From: Michael Stephenson <mstephenson@cameron-cole.com>
Sent: Friday, September 26, 2014 1:03 PM
To: Jump, Christine
Cc: SMITH, MARTIN L
Subject: RE: Underslab sample results for Building B, D and Process Area
Attachments: Concrete Disposal Extent.pdf

From: Michael Stephenson [<mailto:mstephenson@cameron-cole.com>]
Sent: Wednesday, September 24, 2014 3:43 PM
To: Jump, Christine
Cc: Akhter Hossain; SMITH, MARTIN L; mkamal@kdheks.gov; Brady Gerber; sklaus@geostatenvironmental.com
Subject: Underslab sample results for Building B, D and Process Area

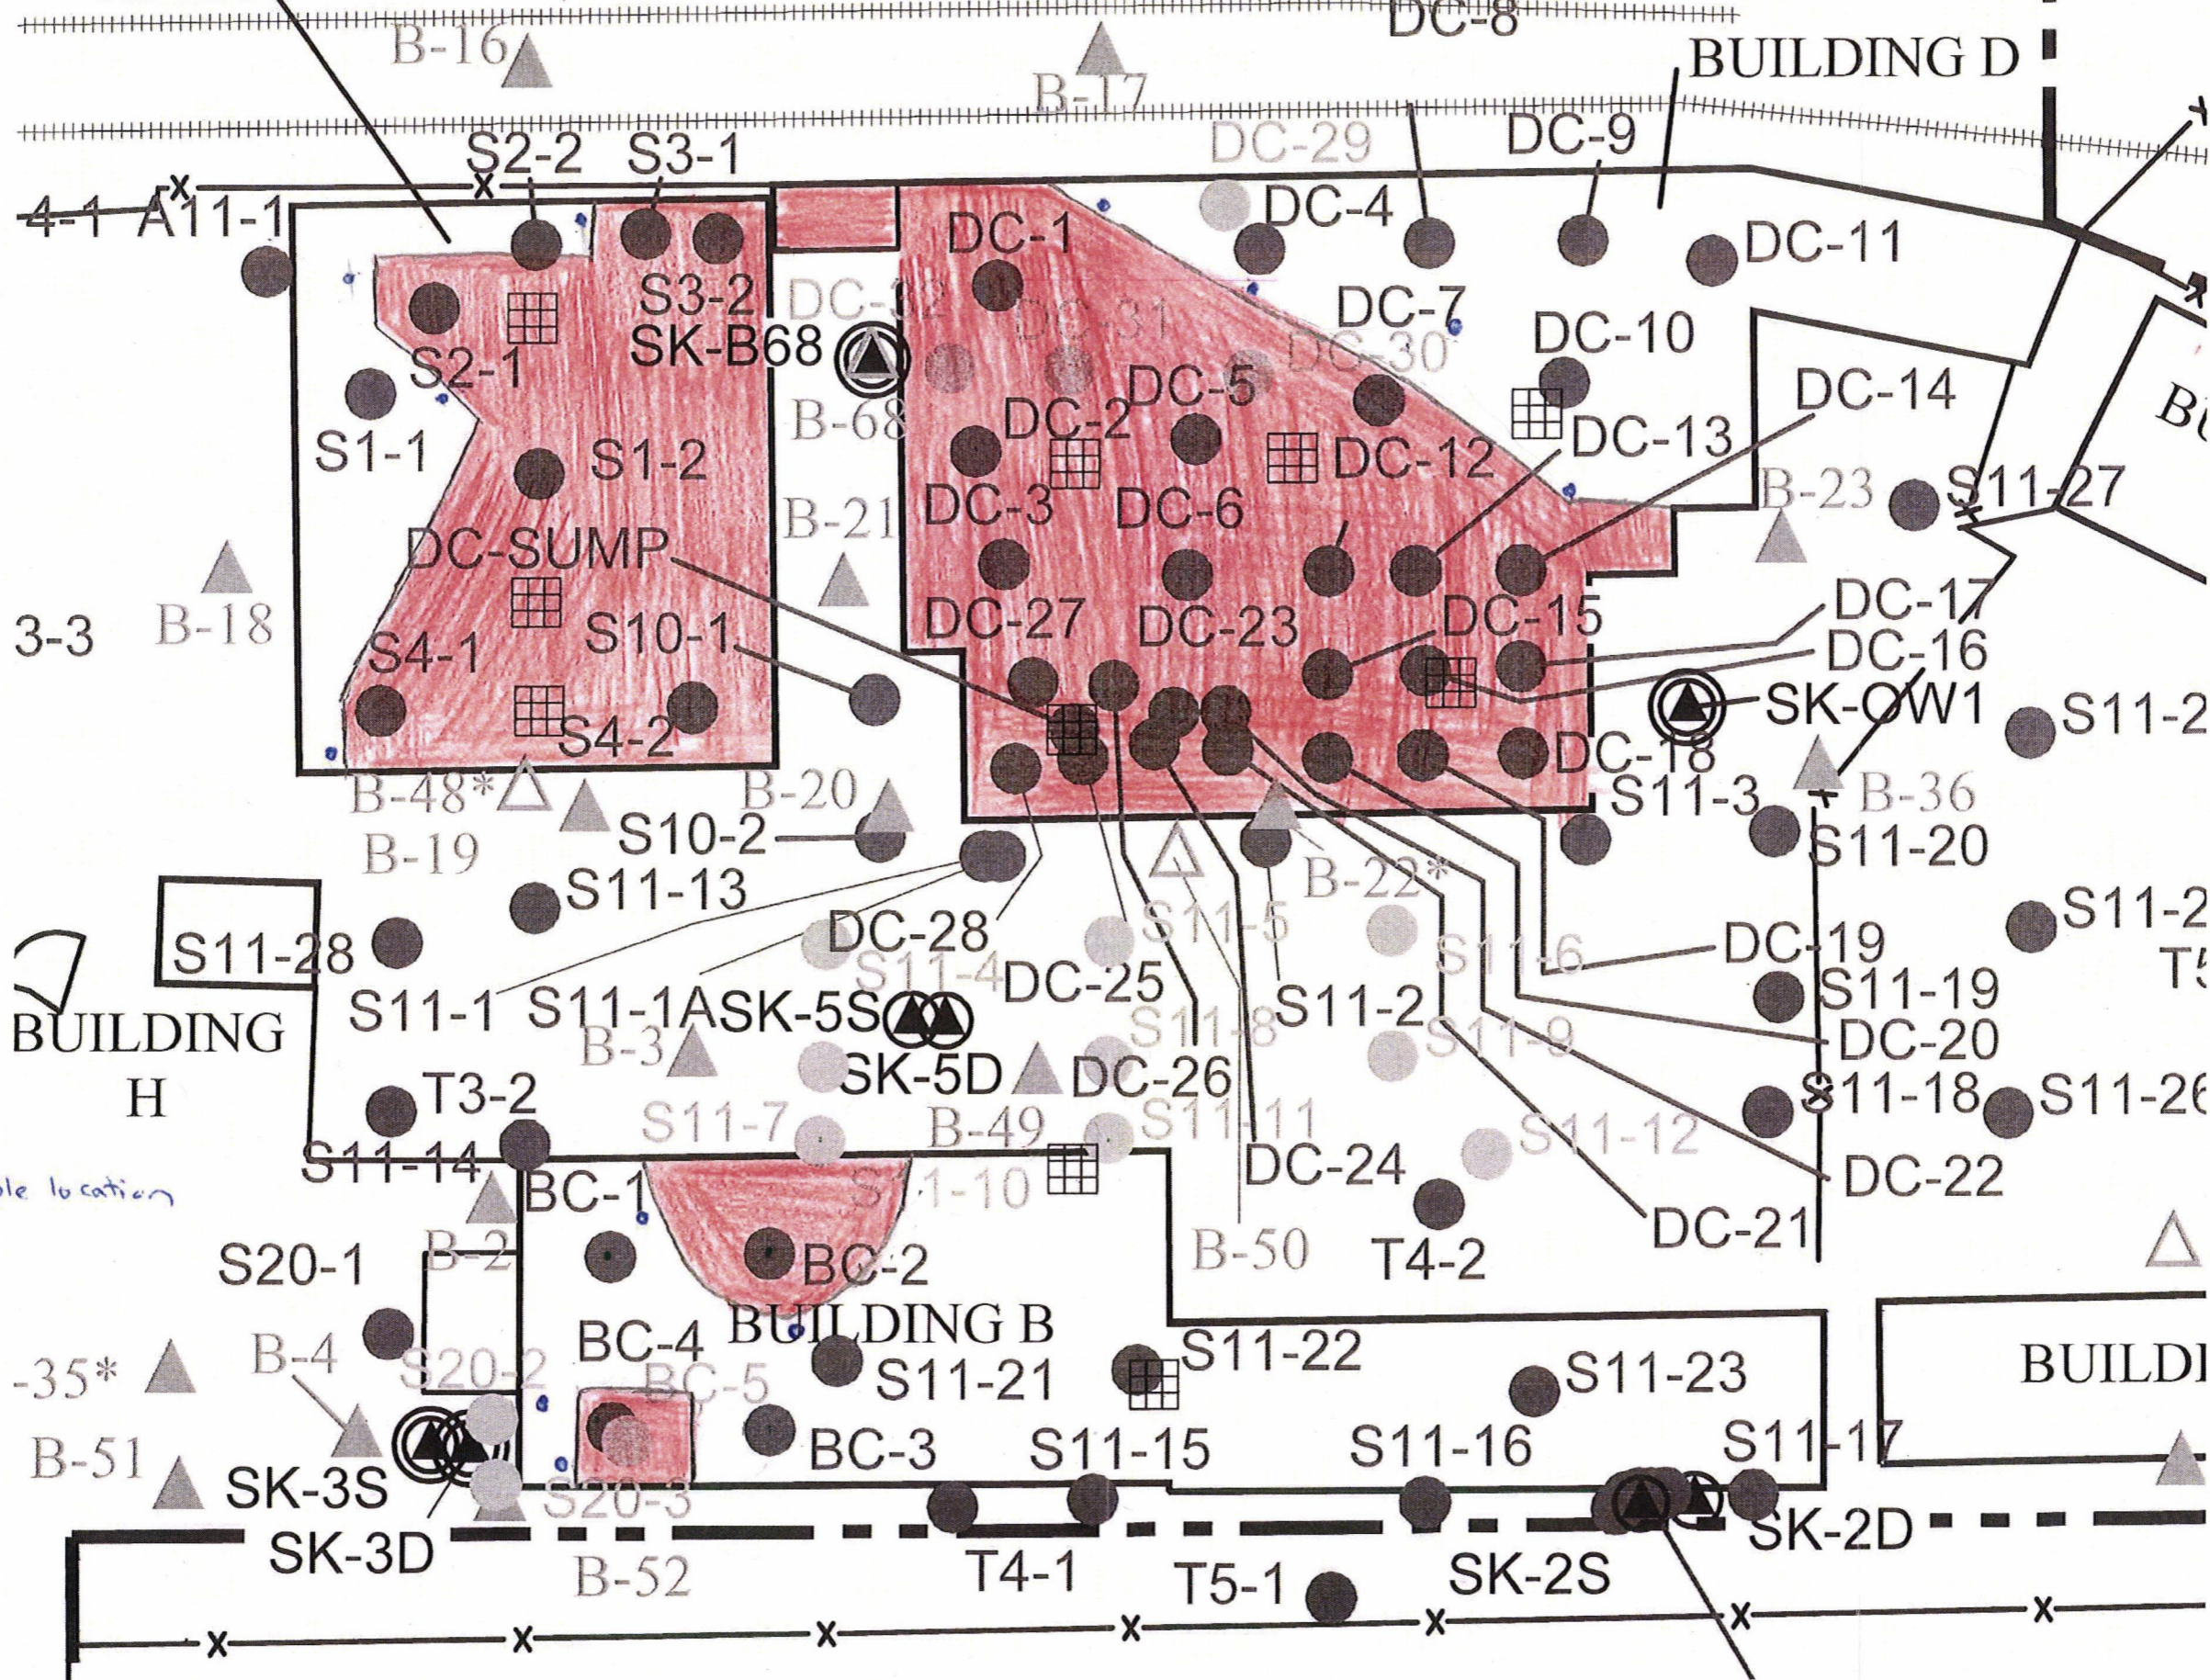
Can you submit figures of the buildings that delineate the areas of concrete you intend to re-use and the areas you intend to send offsite for disposal? The figures can be hand drawn if you like, but I would like something in the file that

shows where samples were collected and the decisions concerning concrete that are based on those samples. Give me a call tomorrow morning if you would like to discuss this,

Attached please find the requested figure which depicts the portions of the concrete floor that will be disposed or re-used as backfill. This follows very closely our original layout and is supported by the recently collected underslab sample data.

As shown in the Table, all results were below IAOs. As such, we plan to proceed with re-use of the concrete overlying the clean soils as originally proposed in the rinsate package submittals.
